CLOVERLEAF SUBDIVISION

GRADING AND EROSION CONTROL PLANS

CLOVERLEAF SUBDIVISION	TYPICAL SECTIONS	BY	DATE
		NO.	REVISION
H-SCALE	1"=5'	V-SCALE	N/A
DATE	06/05/20	DESIGNED BY	NQJ
DRAWN BY	NQJ	CHECKED BY	
SHEET 3 OF 11		JOB NO. 25158.01

GEC Plan_V1_redlines.pdf Markup Summary

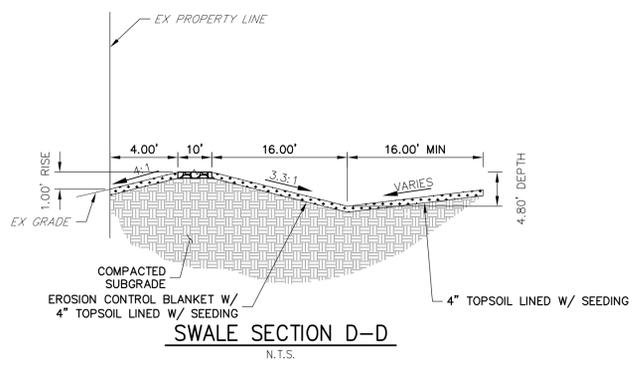
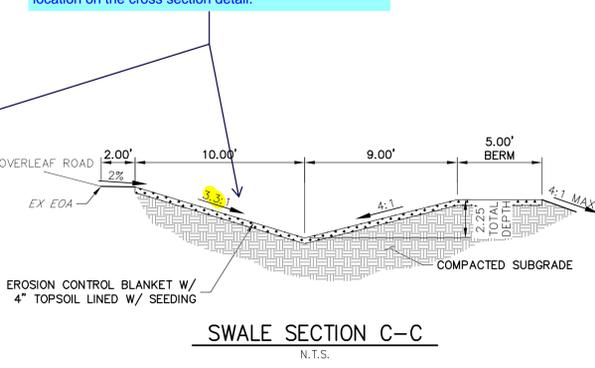
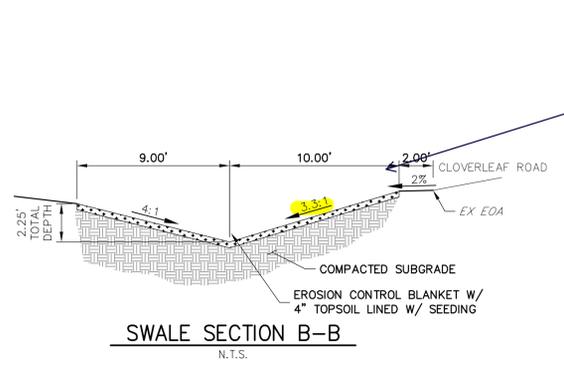
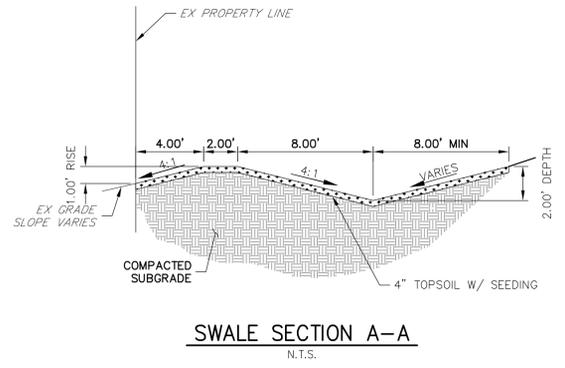
Revise Cross sections. Early grading is for earthwork only. C&G, sidewalk, asphalt, subgrade or storm sewer inlets/pipes installation is not approved.

See snippet below for an example from another project which identifies the rough grading relative to the contours shown on the plans.

provide a footnote defining the **

C&G installation is not approved with the early grading.

Revise. Per the standard road section (detail SD 2-11) the foreslope is 4:1. Show the property/ROW line location on the cross section detail.

Hydraulic calculations for the swales will be required with the final drainage report.

JR Response: Addressed, ** removed

JR Response: Addressed, no proposed c&g shown

JR Response: Addressed.

JR Response: Noted.

CLOVERLEAF SUBDIVISION
GRADING AND EROSION CONTROL PLANS

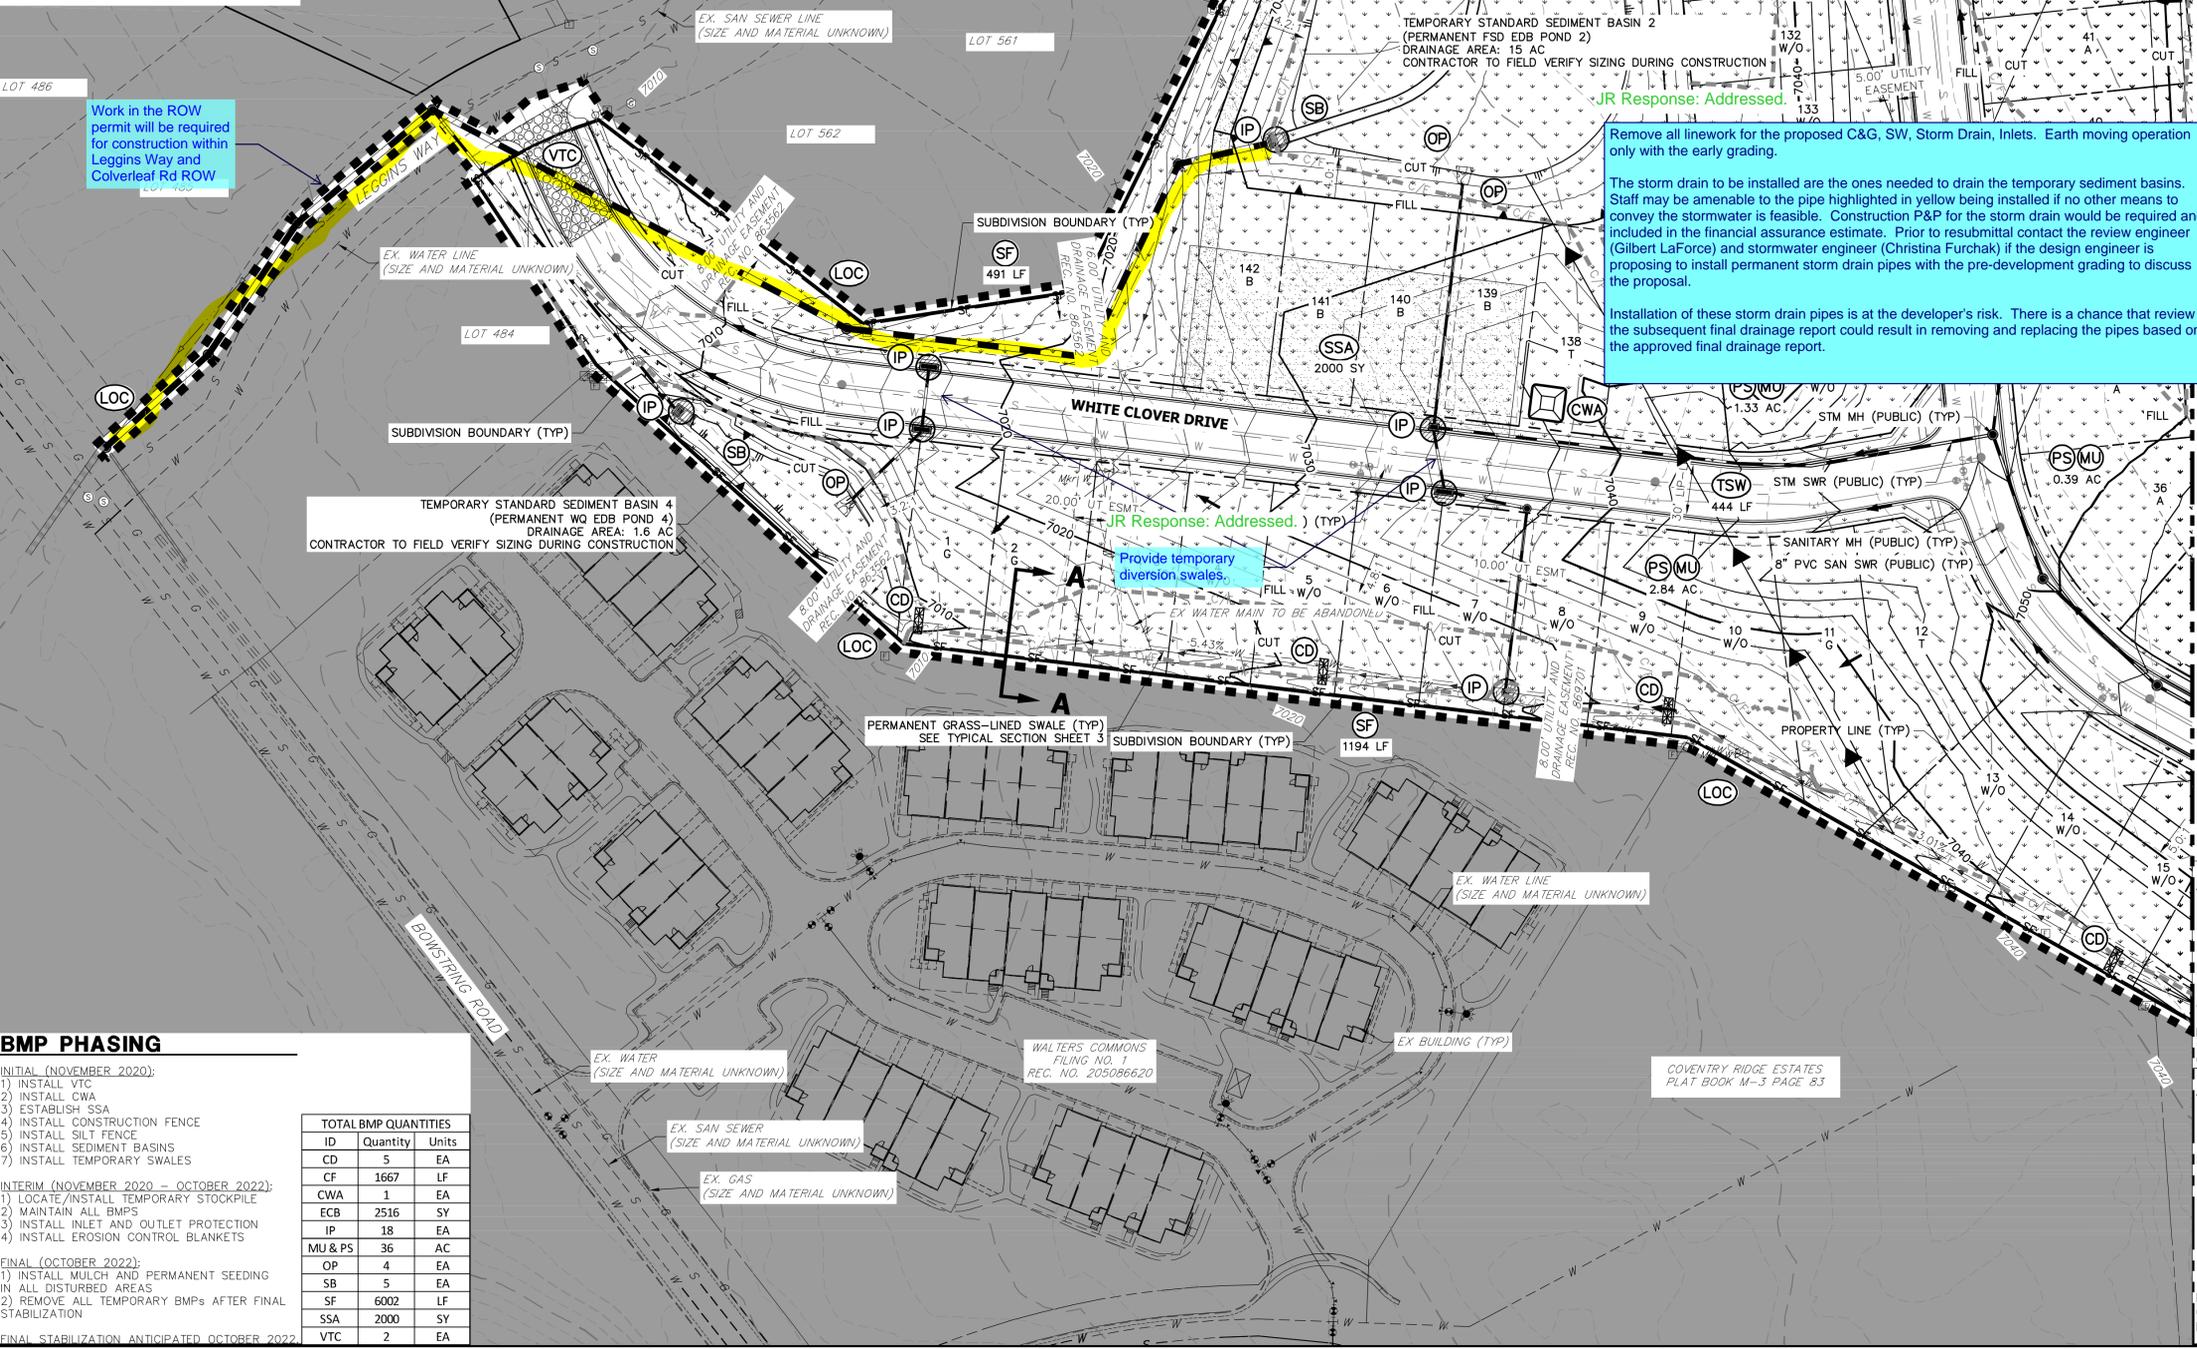
Replace with temporary drainage swales

Provide temporary diversion swales.

Work in the ROW permit will be required for construction within Leggins Way and Colverleaf Rd ROW

Remove all linework for the proposed C&G, SW, Storm Drain, Inlets. Earth moving operation only with the early grading.

The storm drain to be installed are the ones needed to drain the temporary sediment basins. Staff may be amenable to the pipe highlighted in yellow being installed if no other means to convey the stormwater is feasible. Construction P&P for the storm drain would be required and included in the financial assurance estimate. Prior to resubmittal contact the review engineer (Gilbert LaForce) and stormwater engineer (Christina Furchak) if the design engineer is proposing to install permanent storm drain pipes with the pre-development grading to discuss the proposal.

Installation of these storm drain pipes is at the developer's risk. There is a chance that review of the subsequent final drainage report could result in removing and replacing the pipes based on the approved final drainage report.

Show and label the construction fencing.
